PROPOSED HIGHWAY PROJECT WRANGELL, ALASKA EVERGREEN AVENUE IMPROVEMENTS AND PEDESTRIAN ACCESS NH-STP-0003(158)~Z680290000

GRADING, DRAINAGE, PAVING, PATHWAYS, SIGNING, STRIPTING,
RETAINING WALL AND SIDE SLOPE STABILIZATION

As-Builts
Contractor: SECON
Project Engineer: Steve Mielke.
Project Manager: Catherine Wilkins AIA.
Start Date: May 2, 2018
End Date: September 29, 2019

Record Drawings have been reviewed by the Project Engineer, and represent to the best of my knowledge, the project as constructed.

PLAN & PROFILE

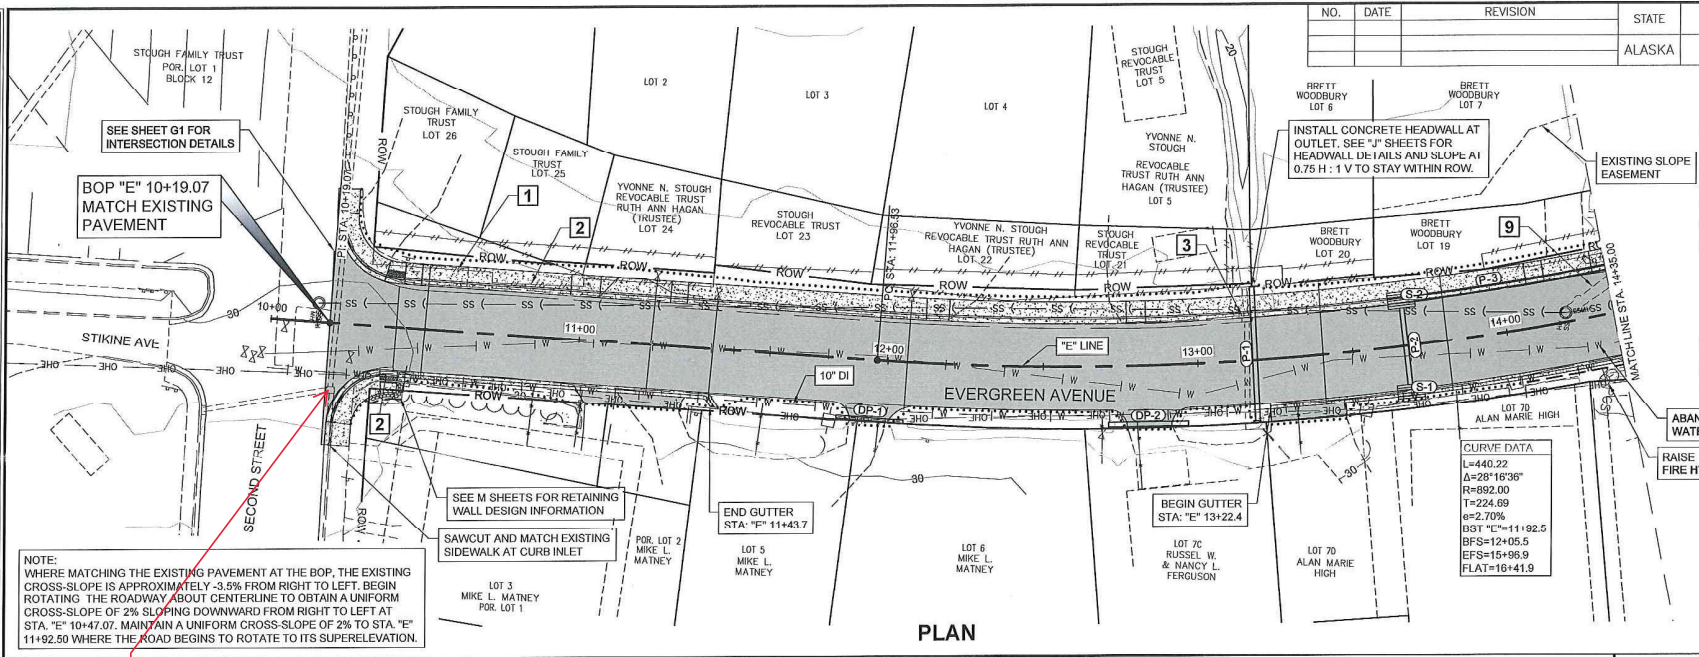
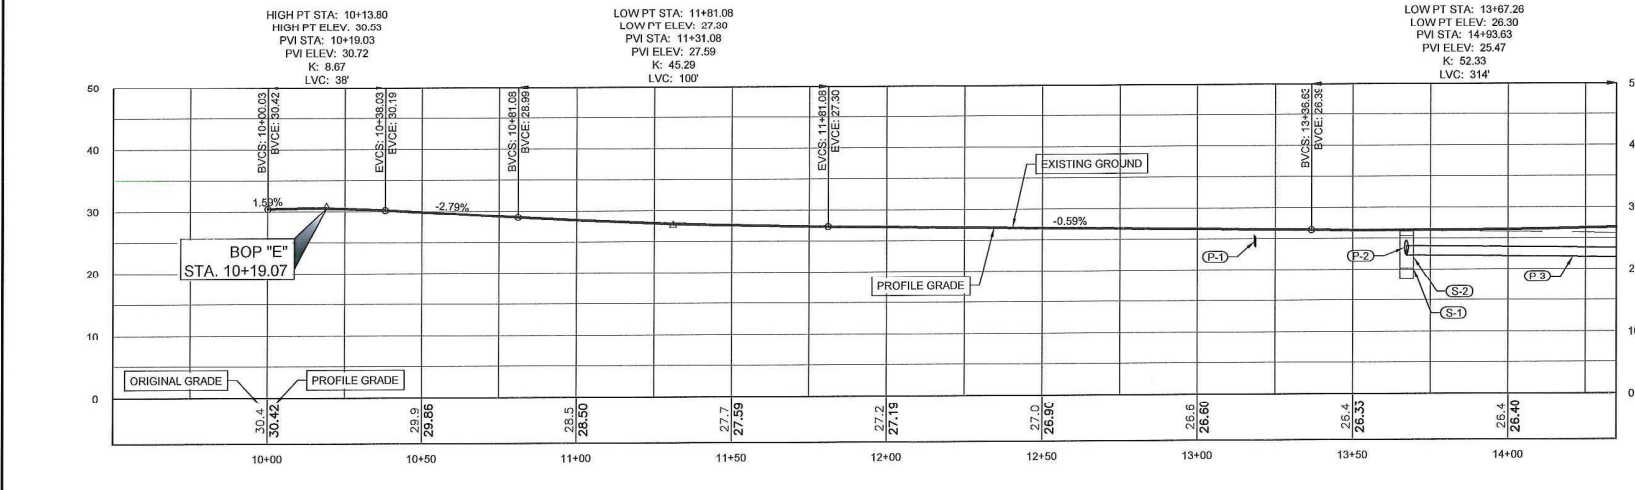
604(10A) Modify existing cast-in-place field inlet at Station 10+22, 22' RT. by lowering riser approximately 6" replacing existing slotted drain w/new frame & lid, and setting flush w/finished pavement surface.

ATTACHMENT 2 - SHEET F16(a)

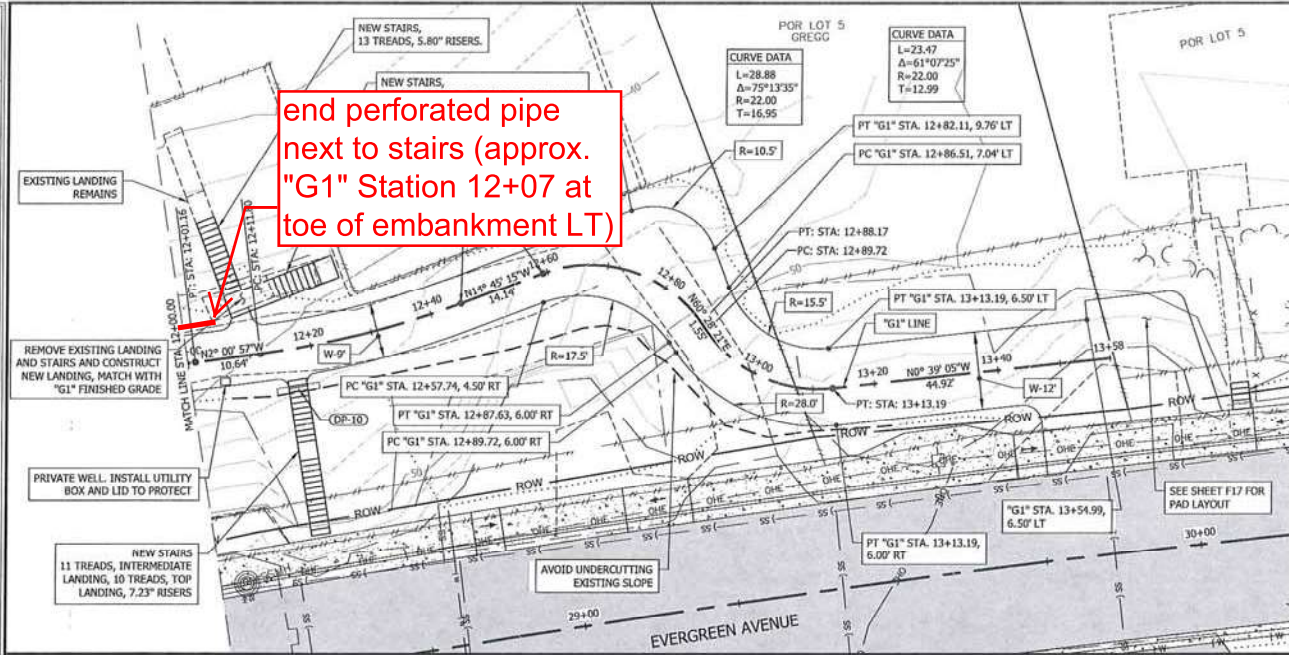
Est. New Pay Item 603(22)
 Drainage Modifications is to ensure that sheet flow & concentrated runoff on property adjacent to the G1 alignment is properly contained, routed & discharged in a manner that doesn't induce erosion to the driveway, yard, or adj house. This new item provides a means for the action item noted as "Channel Drainage around structure" in plan sheet F15. to be performed as well as alleviate drainage issues that have arisen since the construction of the G1 alignment was completed.

STOUGH'S TRAILER COURT
PLAN & PROFILE

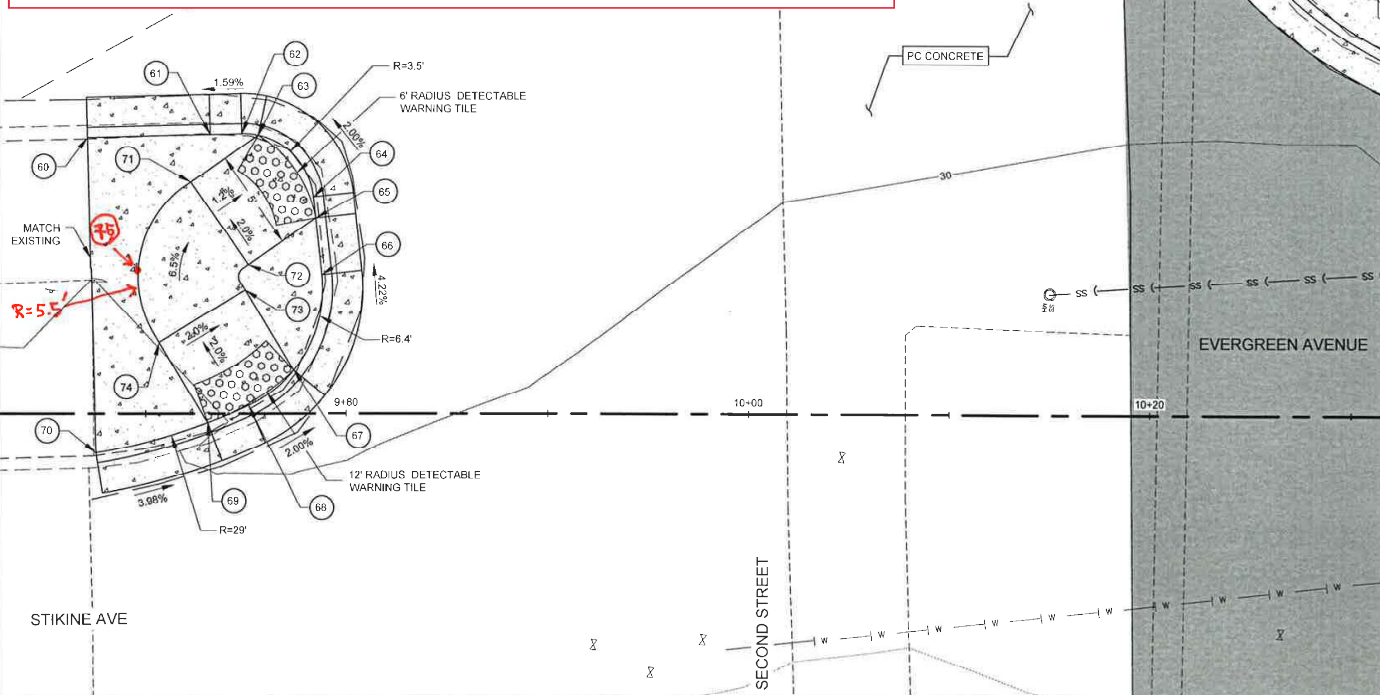
Change Order #11. Establish New Item 608(10) Reconstruct BOP. Bulb Out.
Description: Reconstruct existing Concrete Island near BOP. to ADA standards to accommodate relocation of existing crosswalk. Work to include the following:
 *Remove and dispose existing concrete sidewalk, curb & gutter as required to reconstruct sidewalk.
 * Furnish @ sets of detectable warning tiles as required (to include expedited shipping & handling costs).
 * Construct concrete curbs, ramps, landings and sidewalk per the Plans and drawing (Attachment No.1).
